# CITY OF ALBUQUERQUE

**RE: Iron Duplex - Resubmittal  
Grading and Drainage Plan  
Original Stamp Date: 11/22/16  
Revision Stamp Date: 4/4/17  
Hydrology File: K13D074**

## DRAINAGE AND TRANSPORTATION INFORMATION SHEET

|                                                                                 | GRADING AND DRAINAGE PLAN | DATE 11-02-16         |

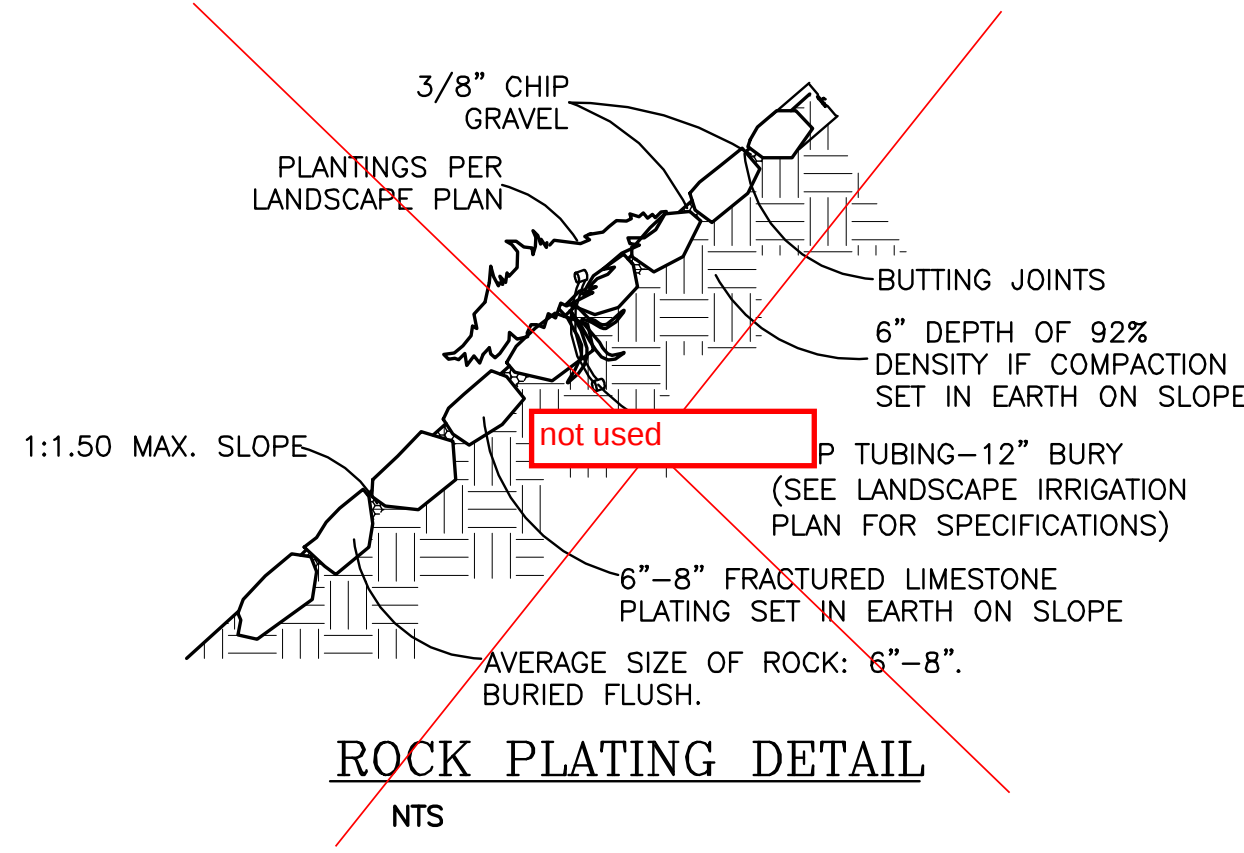
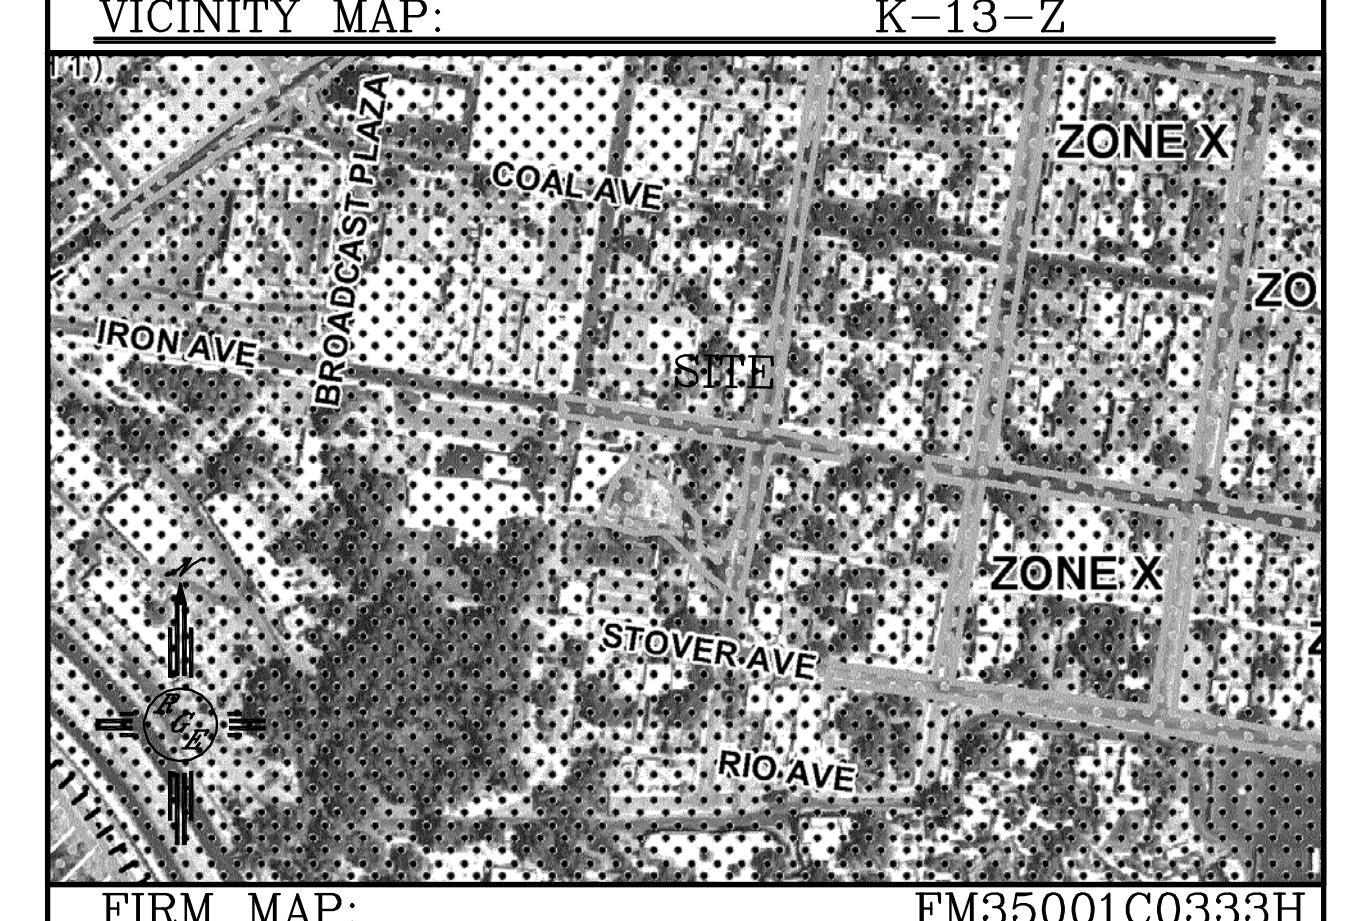
1. As a constructability issue, it is hard to tell what you are installing and what you are not. Please place a big "X" over the old ponds and driveway. Then place a new viewport showing what you are proposing to install. It will make it a lot easier for both the contractor and the building inspector to immediately see what is to be built.
2. It appears that the 6'x7'x48' trench is drawn 47'. Please check the length of the trench.
3. Please provide a detail for the trench. Again this will help both the contractor and the building inspector know what is to be built.
4. The proposed trench is to provide 520 CF of retention. The required retention is 530 CF. It appears that your new system is about 10 CF short.
